"NRC Technical Assistance
for Design Reviews"
Contract No. NRC-02-85-002
FIN D1016

ITASCA DOCUMENT REVIEW

Document Title: Summary Review of Thermomechanical Room-Scale Testing at WIPP

Reviewer: Itasca Consulting Group, Inc.
(B. Brady, L. Lorig and K. Wahi)

Fig. 6 Room B Configuration Used in Pretest Reference Calculations [Morgan and Stone, 1985b]

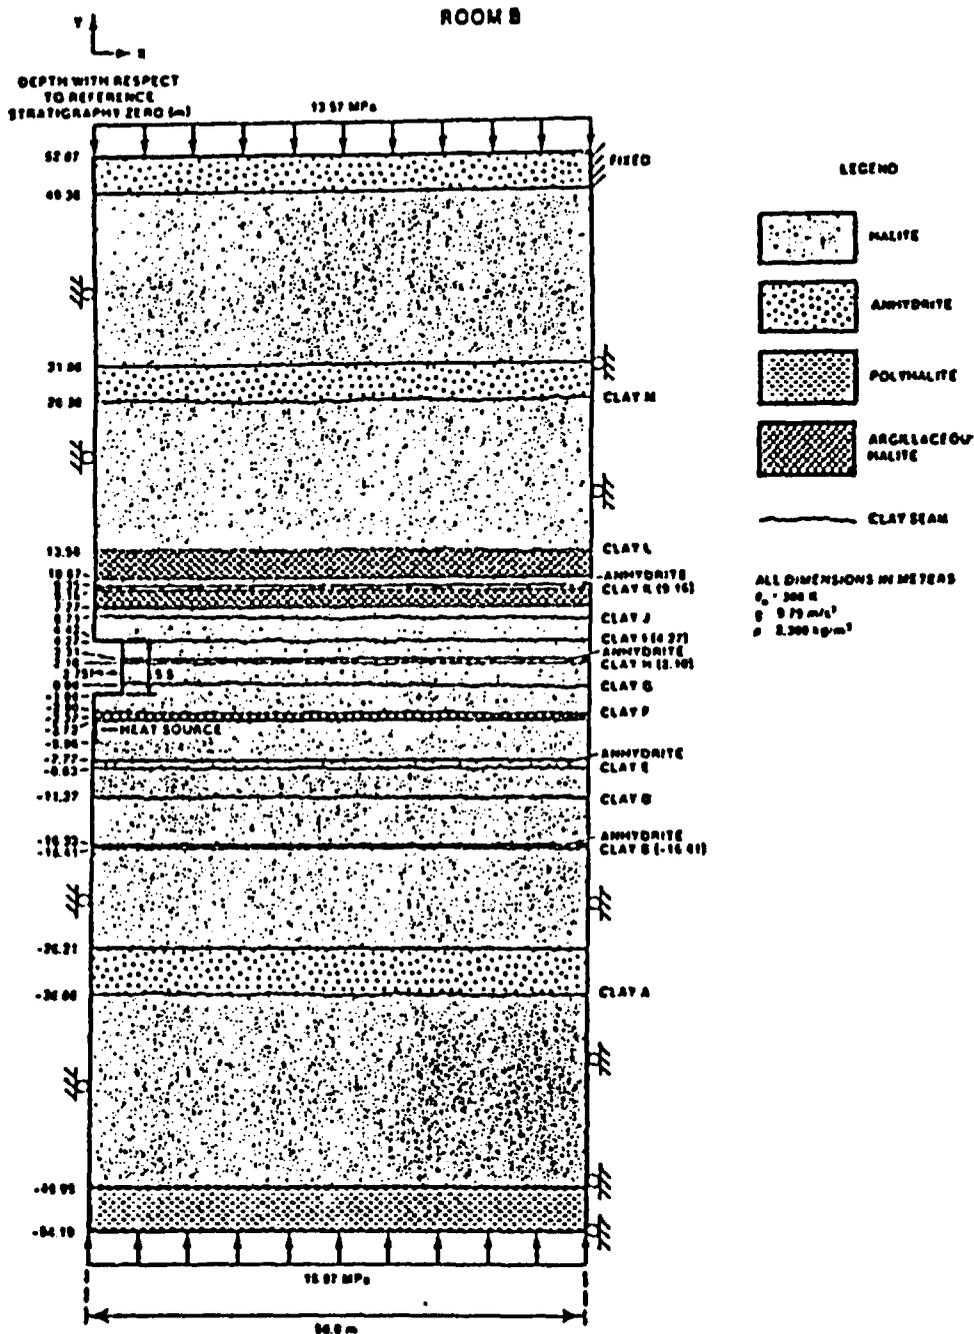
It is stated on p.69 of the Room B document [Morgan and Stone (1985b)] that, "Deep in the pillar, ...vertical and out-of-plane stress components never deviate much from the initial lithostatic value." The results shown in Figs. 54 and 55 of the document contradict that statement.

For Room B, only Phase I is modeled in the pre-test calculation. Phase II (backfilling) and Phase III (retrieval/re-excitation) of the experiment are also very important—both from a modeling and a licensing perspective. Only one part of the Room G Experiment is modeled that also happens to be the least complicated. Presumably, other calculations are being made or will be made to predict the response due to widening and the three-dimensional response.

Fig. 7 Room G Configuration in the Pretest Reference Calculation [Morgan and Stone, 1985c]

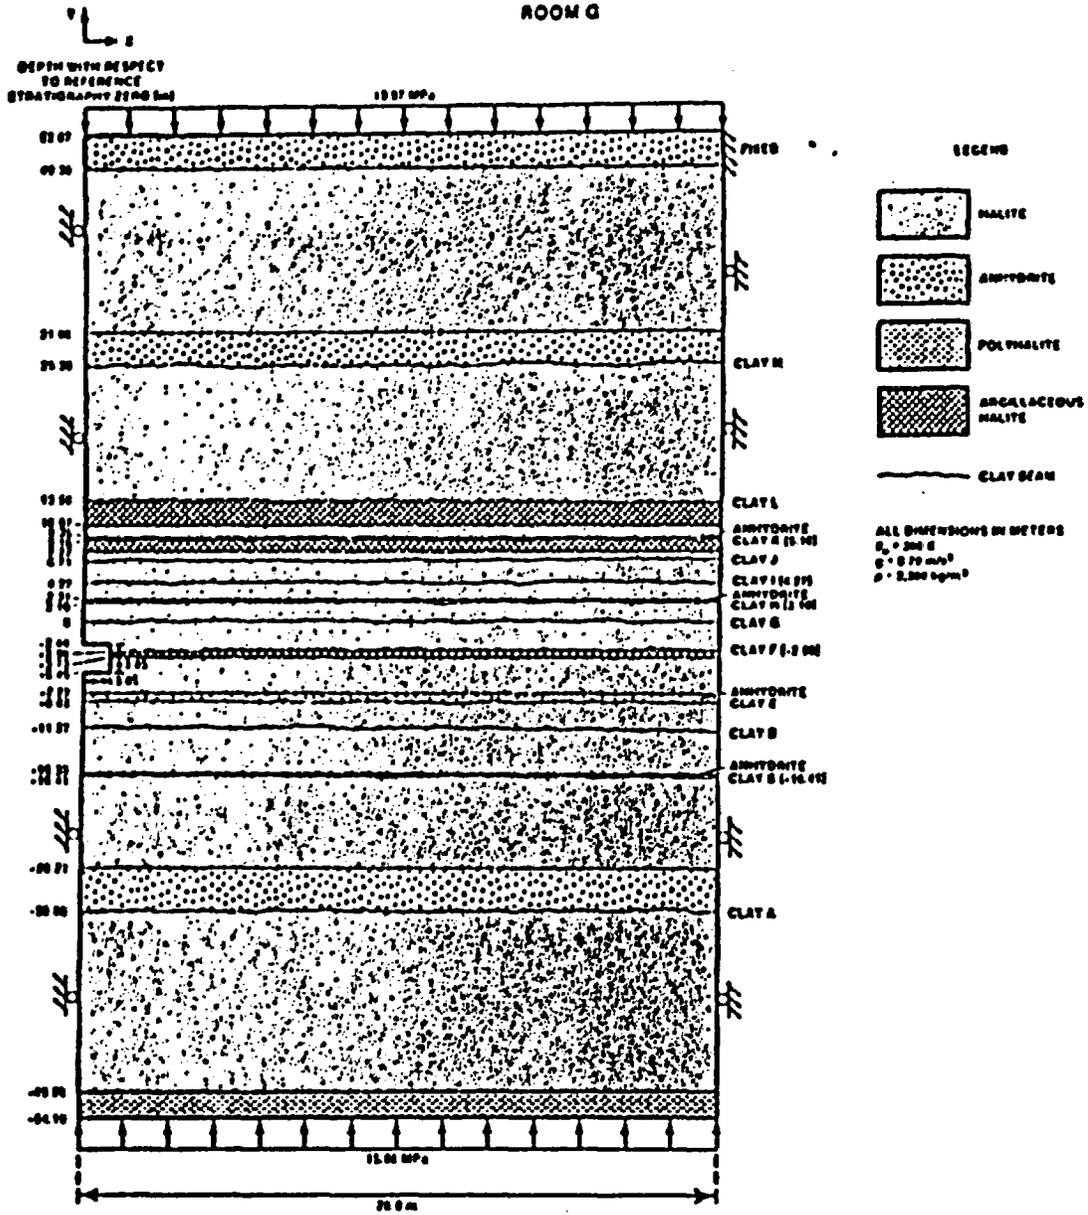
In the Room G response, it is not clear why the roof sag is 50% higher than the floor heave at ten years. One likely explanation is the larger distance from the free surface (roof horizon) to the nearest anhydrite layer above compared to the distance below the floor horizon to the nearest anhydrite layer. The manner in which anhydrite is modelled and the strength properties associated with the material have a major influence on the structural response of the opening.

Fig. 8 Revised Relative Slip Across the 650.2m Slide Line for the Heated Room at One, Two and Ten Years [Morgan et al., 1981]

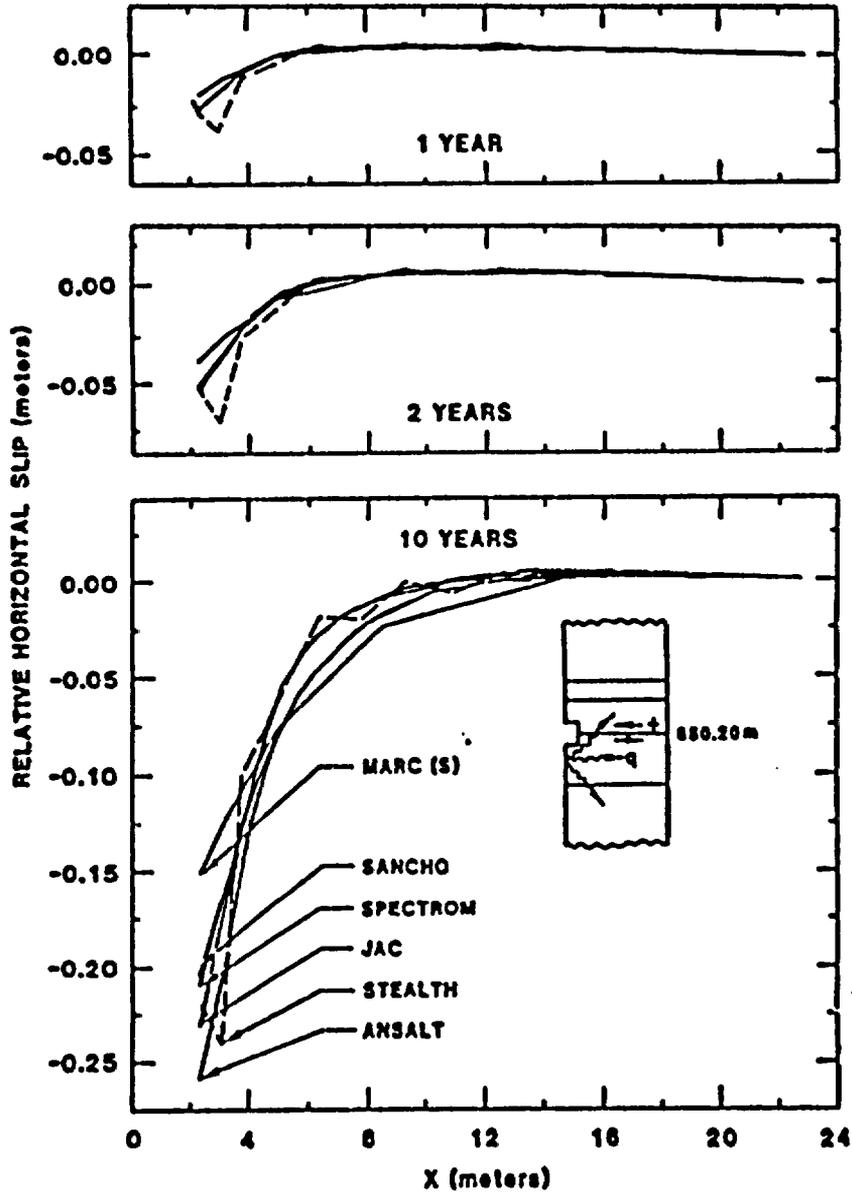
It is somewhat surprising that the slip along Clay G and/ or Clay H is negligible in the Room A and Room B response predictions. In a benchmark calculation for WIPP for a similar configuration, significant slip was predicted along a slideline near pillar mid-height. Fig. 8, reproduced from Morgan et al (1981), indicates the slip magnitude for a slideline comparable to Clay H.
